CAHILL PLACE SUBDIVISION

APPLICATION NUMBER 2 DATE March 5, 2009

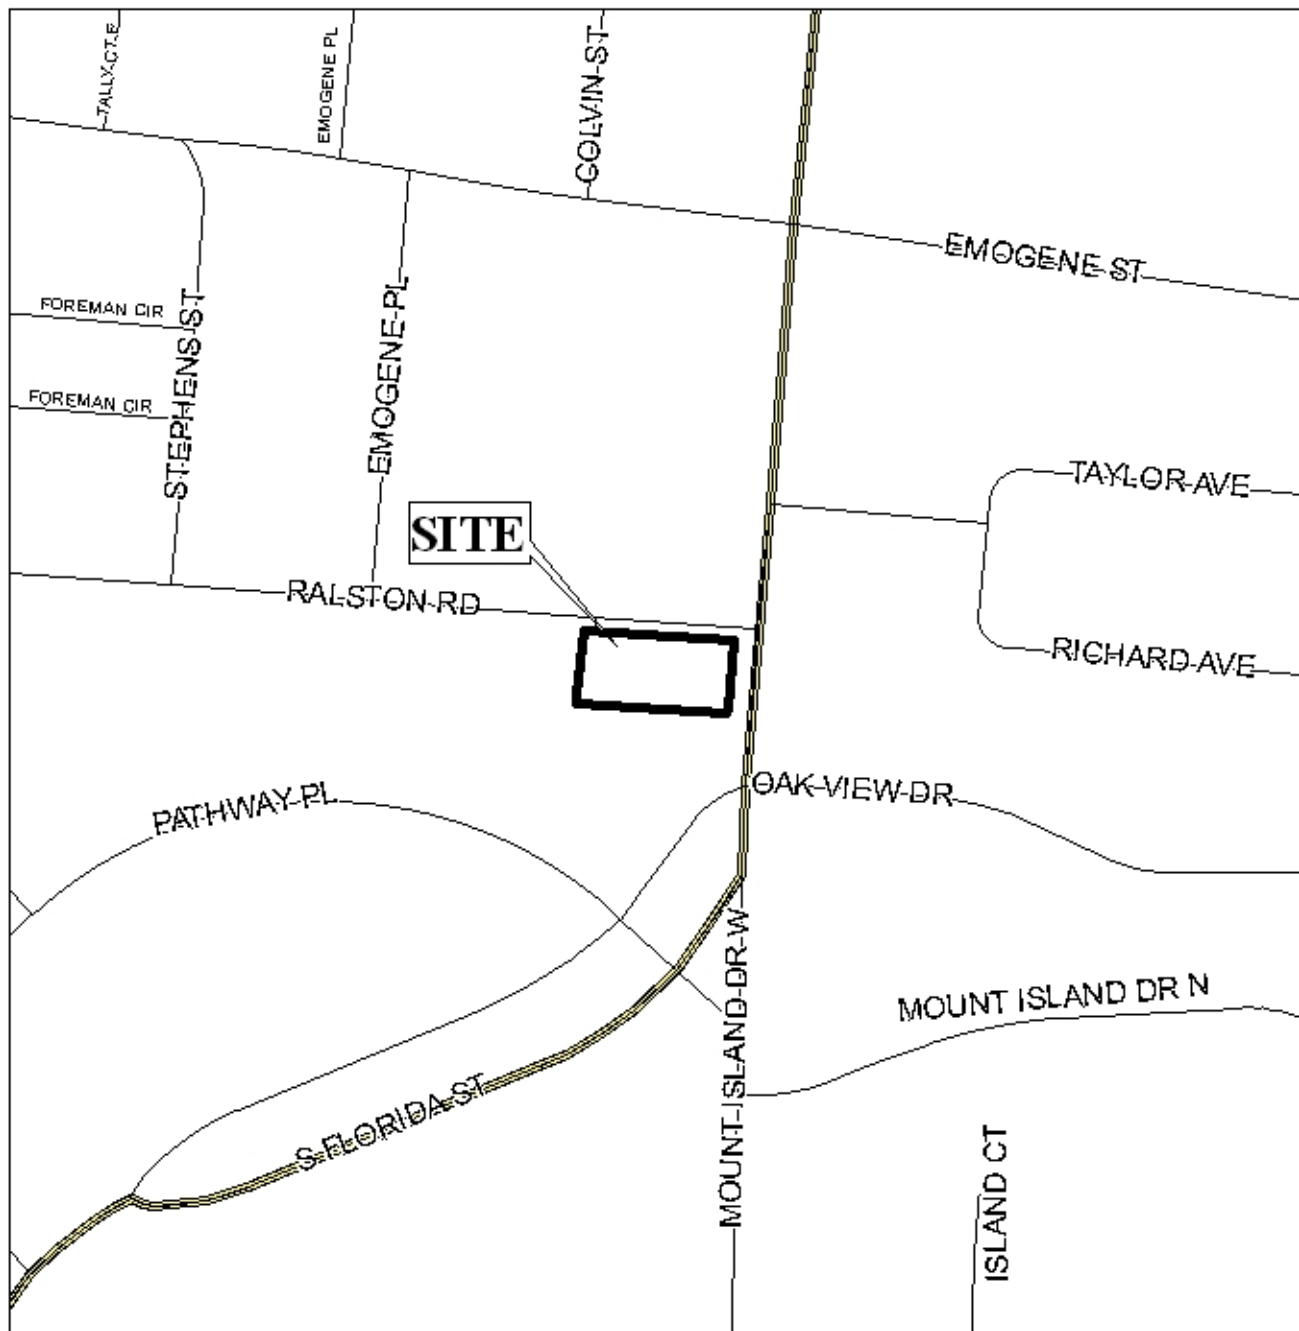
The site has approximately 120-feet of road frontage on South Florida Street and approximately 243 feet on Ralston Road. Since this development has minimum frontage on a major street and extensive frontage on a minor street access management is a concern; therefore, a note should be place on the Final Plat stating that the development is limited to one curb cut to Ralston Road and one curb cut to South Florida Street, with the size, location, and design to be approved by Traffic Engineering and conform to AASHTO standards.

As proposed, the plat does not illustrate adequate radii where Ralston Road intersects with South Florida Street. The Final Plat should be revised to comply with Section V.B.16. of the Subdivision Regulations, with the size and design to be approved by Traffic Engineering and conform to AASHTO standards.

It should also be noted that the existing structure is connected to an existing second story wood structure; therefore, a Planned Unit Development (PUD) application would be required as well, or the removal of the connection. Planned Unit Development (PUD) application is required due to the adjacent developments possibly shared parking, or by sharing of a structure such as this development across lot lines.

- 1) dedication of sufficient right-of-way, South Florida Street, to provide a minimum 50-feet as measured from the centerline of South Florida Street;
- 2) placement of a note on the Final Plat stating that the development is limited to one curb cut to Ralston Road and one curb cut to South Florida Street, with the size, location, and design to be approved by Traffic Engineering and conform to AASHTO standards;
- 3) provision of adequate radii, in compliance with Section V.B.16. of the Subdivision Regulations, at the intersection of South Florida Street and Ralston Road, with the size to be determined by Traffic Engineering and conform to AASHTO standards; and
- 4) submission of a Planned Unit Development (PUD) application.
